**REMARKS**

This Amendment is in response to the Official Action mailed December 8, 2003, the shortened statutory period for filing a response expiring on March 8, 2004. Applicants submit herewith a three-month extension petition to reset the deadline for responding to the Official Action to and including June 8, 2004. In view of the following remarks and claim amendments, reconsideration of the Examiner's rejections and Notice of Allowance of all pending claims is respectfully requested.

ANNOTATED SHEET  
SHOWING CHANGES

FIG. 1

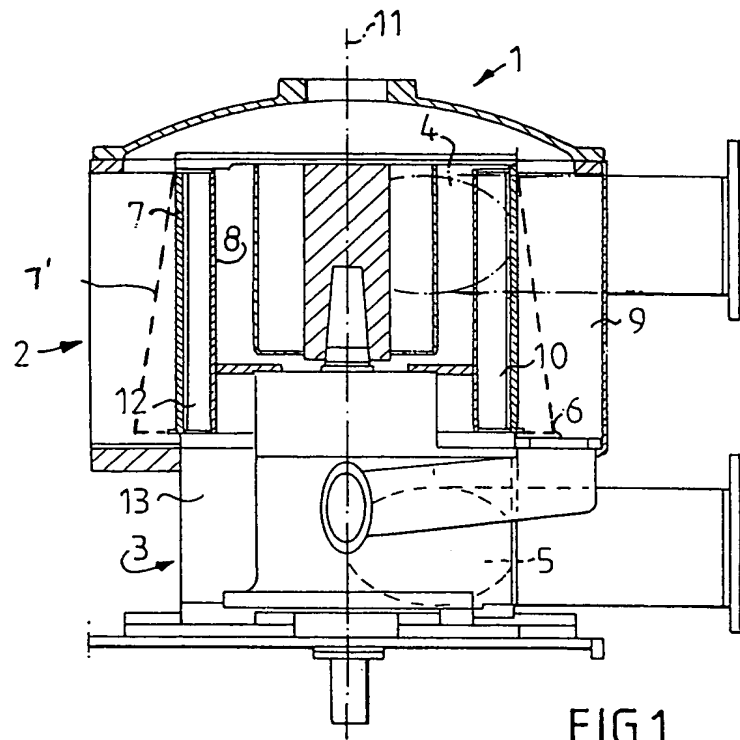
The drawings have been rejected under 37 C.F.R. § 1.83(a) for failing to show every feature of the claimed invention. Specifically, the Examiner contends that the drawings fail to show the cone shaped rotary screen claimed in claim 16. Applicants have amended Fig. 1 to clearly depict a cone shaped rotary screen. In accordance with a preferred embodiment of the invention, the cone is shown to increase in diameter in the direction facing toward the accept outlet. For ease of distinction between the cone shaped rotary screen and the cylindrical rotary screen 7, the cone shaped rotary screen has been shown in phantom lines and has been annotated as 7'.
